## WILLIAMSON COUNTY, TEXAS

CHANGE ORDER NUMBER: 6

Project:	<u>1604-068</u>
Roadway:	<u>Forest North Drainage Ph 1</u>
CSJ Number:

### **Forest North Phase 1 Williamson County Project No. 1604-068**

X:\Projects\0300 - Forest North Phase 2\DCN\Sheets\0300\*SK\*PP07.dgn modified by vortega on 8/9/2017 - 6:24:35 PM

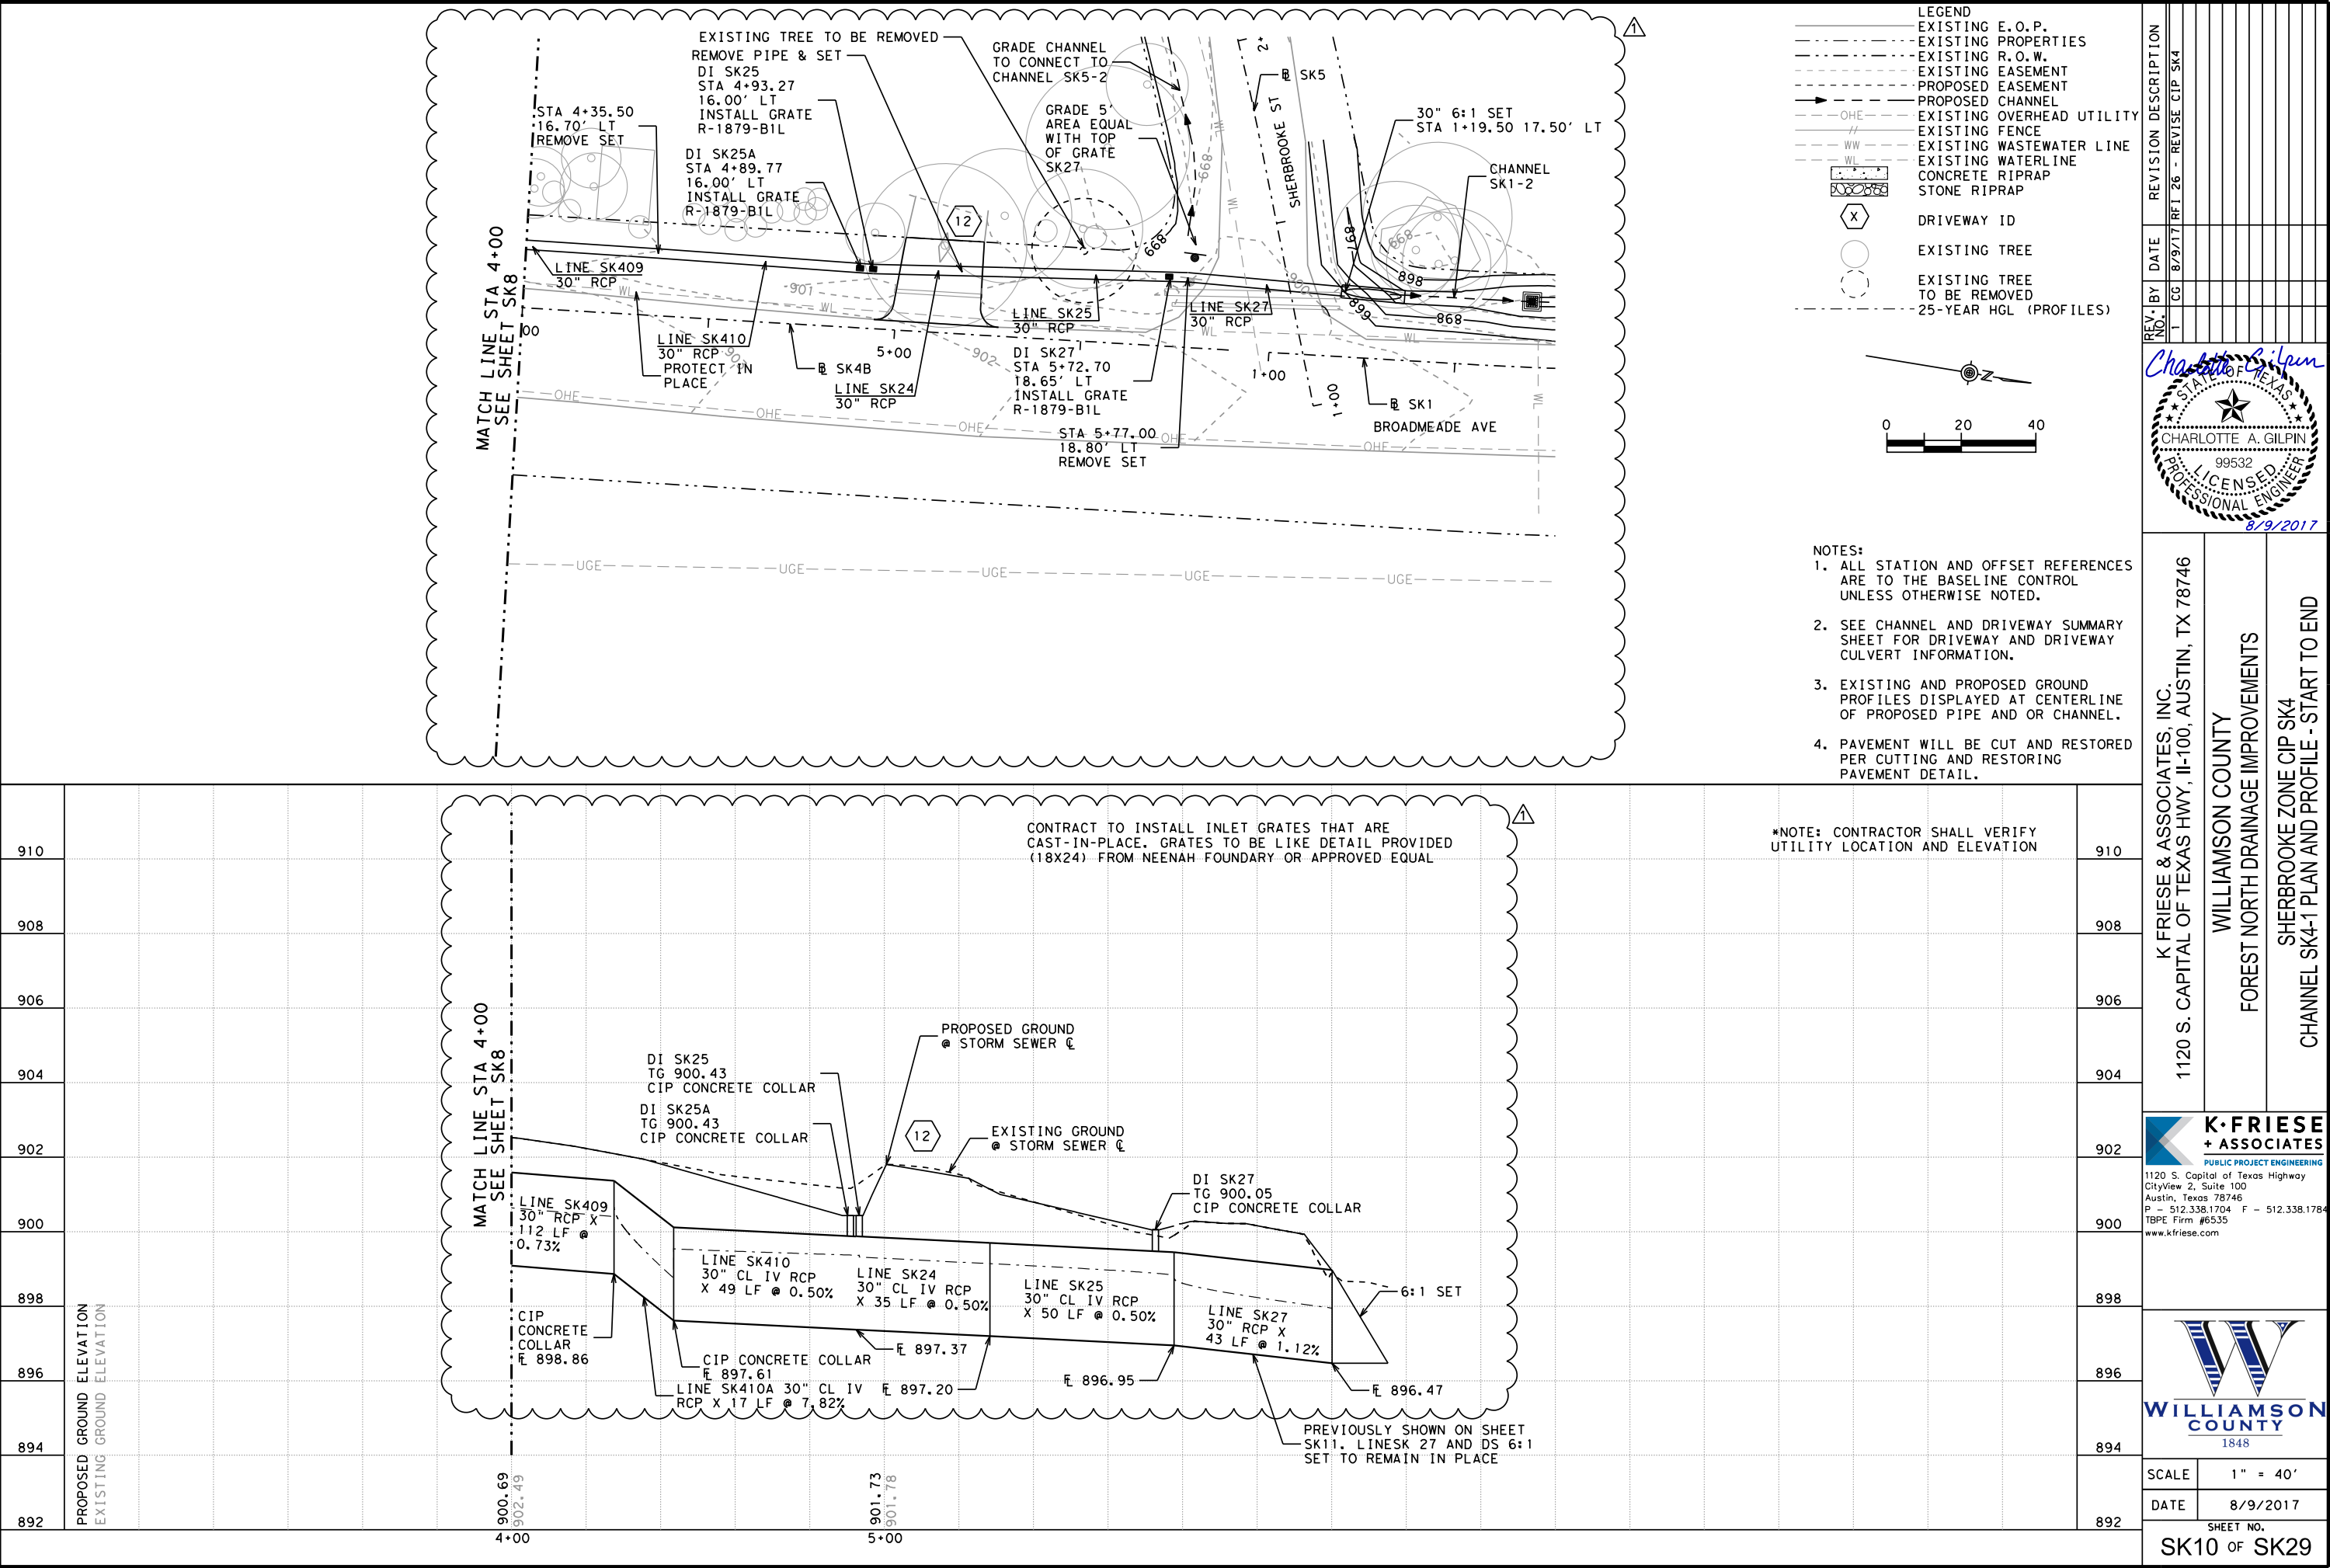
**3F: County Convenience. Additional work desired by the County.** This Change Order revises drainage work at the corner of Broadmeade and Sherbrooke Street in the Sherbrooke Zone. After review, the County requested that the open ditch design be changed to an underground pipe system due to the depth of the ditches.

The County has requested that the ditches on either side of Driveway 12 at the corner of Broadmeade Avenue and Sherbrooke Street be enclosed with an underground drainage system. Please provide a design for this underground system.

The proposed solution requires Driveway 12 to be removed and replaced and three additional grates. The plans and grate cut sheet are attached.

This Change Order revises drainage work at the corner of Broadmeade Avenue and Sherbrooke Street in the Sherbrooke Zone. After review, the County requested that the open ditch design be changed to an underground pipe system due to the depth of the ditches. The additional work consists of removal of existing safety end treatments, removal of a portion of Driveway 12, installation of new pipe, installation of inlet grates on top of the pipe, replacement of Driveway 12, backfilling of pipe, grading, topsoil and seeding.

Note: The Lump Sum cost for Item 999-WC06 includes the cost of removal and haul off of 4 safety end treatments, installation of 3 – (18" x 24") inlet grates, concrete collars between new pipe and existing pipe, the additional cost for the Class IV pipe compared to the Class III pipe, and the removal / replacement of Driveway 12.
